Company	Trenz Electronic GmbH
PCN Number	PCN-20190430
Title	TE0714-02-* to TE0714-03-* Hardware Revision Change
Subject	Hardware Revision Change
Issue Date	2019-07-15

This change affects all Trenz Electronic TE0714-02 SoMs: TE0714-02-*

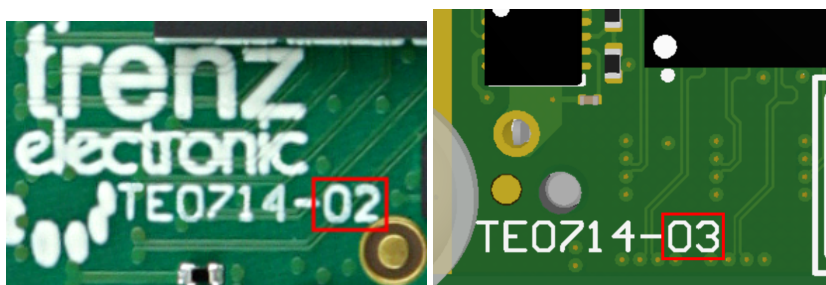
#6 Optimized testpoints placement

Type: PCB change

Reason: Prepare for automated testing
